26019-01b Transport Assessment PART 2

Project Title
Catalyst Bicester Phase 4, Wendlebury Road, Bicester

Drawing Title
**S278 WORKS
General Arrangement Plan**

Road Safety Audit
Stage 1

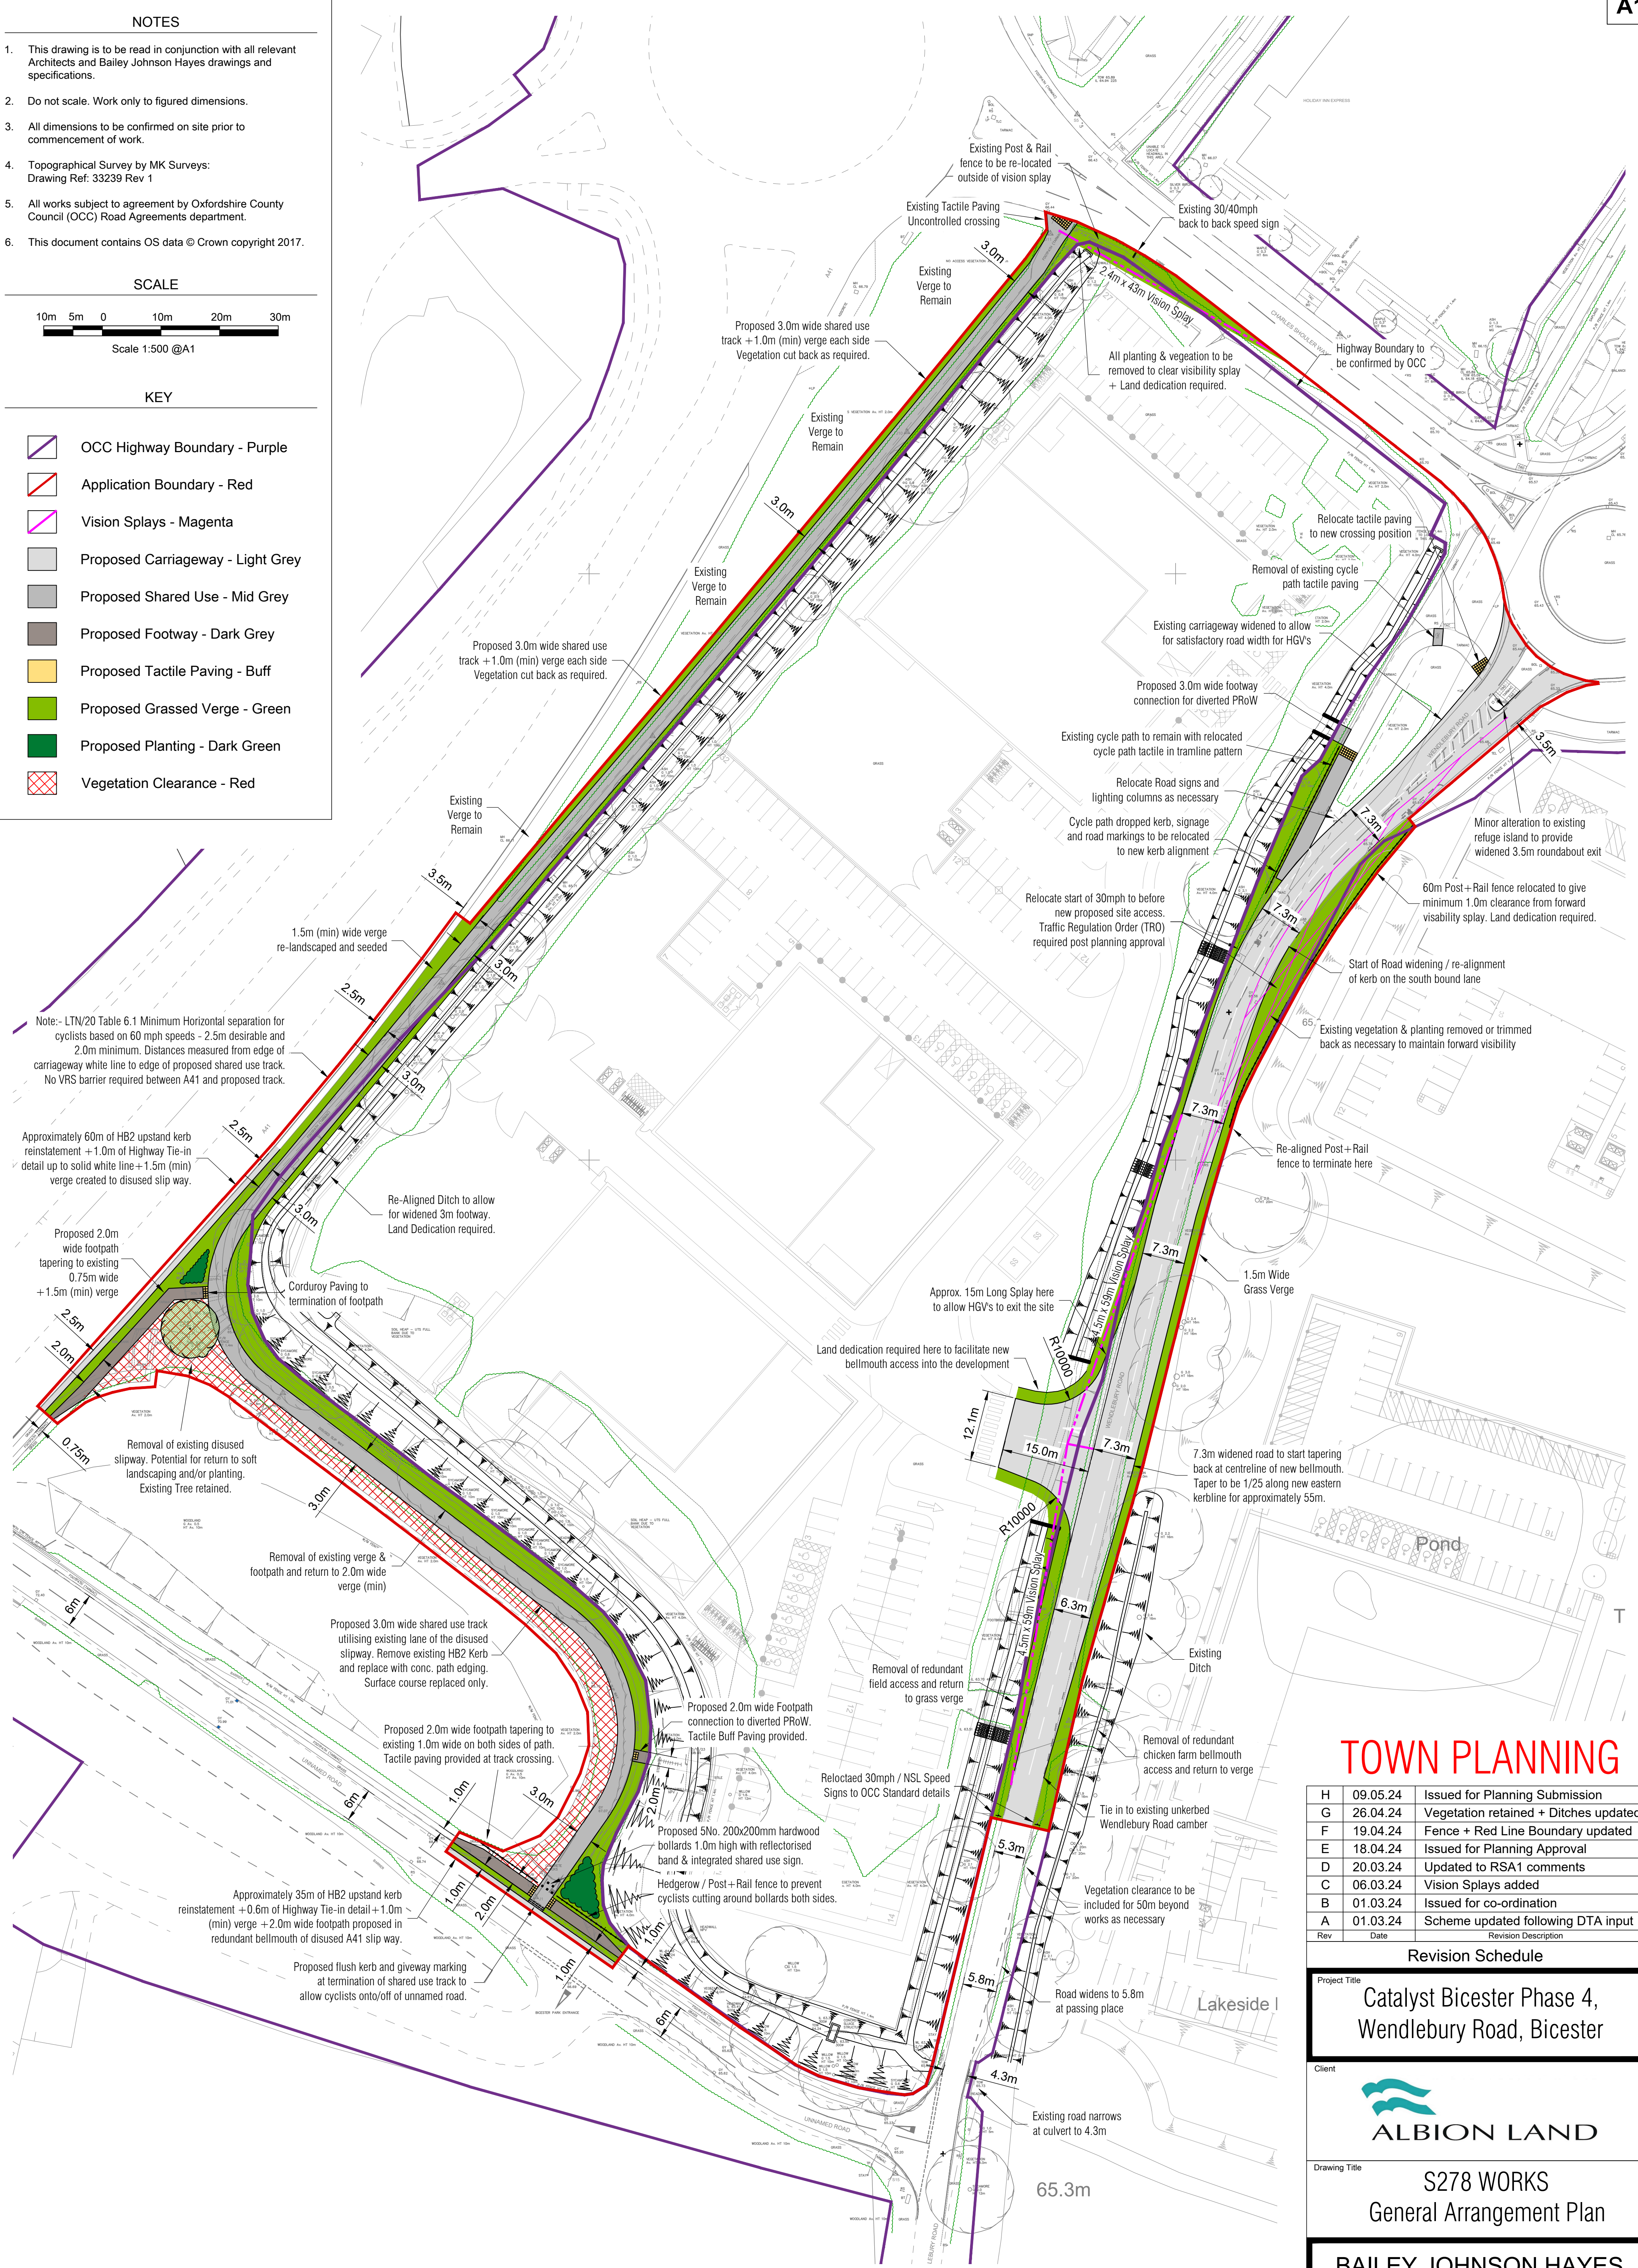
H	09.05.24	Issued for Planning Submission
G	26.04.24	Vegetation retained + Ditches updated
F	19.04.24	Fence + Red Line Boundary updated
E	18.04.24	Issued for Planning Approval
D	20.03.24	Updated to RSA1 comments
C	06.03.24	Vision Splays added
B	01.03.24	Issued for co-ordination
A	01.03.24	Scheme updated following DTA input
Rev	Date	Revision Description
